SERVICE BULLETIN # 1093A

MODEL **MAC D30, D36** DATE 5/11/60

SUBJECT **REPLACEMENT OF REED PLATE ASSEMBLY**

NEW REED PLATE ASSY
MAC D30 AND D36

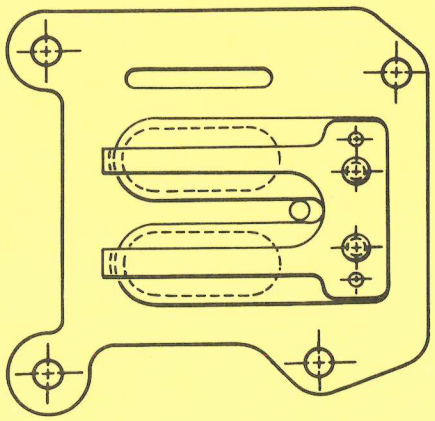
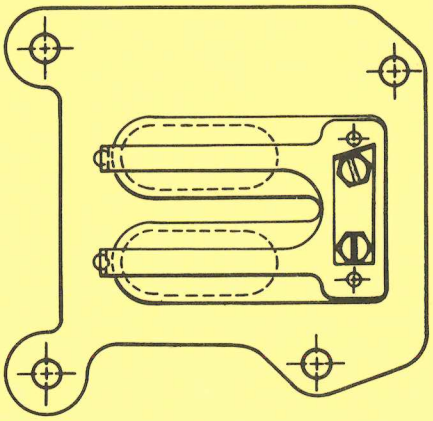
Reed Plate Assembly, P/N 50747A, which is used on Model 1-40, 1-50, and 1-60 engines, has replaced the earlier reed plate assembly, P/N 50044, used on MAC D30 and D36 engines.

When installing 50747A Reed Plate Assembly on a MAC D30 or D36 engine, insert a new Foam Absorber, P/N 57457, into the crankcase third port cavity (see illustration below). The Foam Absorber increases horsepower by reducing engine resonance, prevents fuel puddling, and eliminates engine cut out at idle speed.
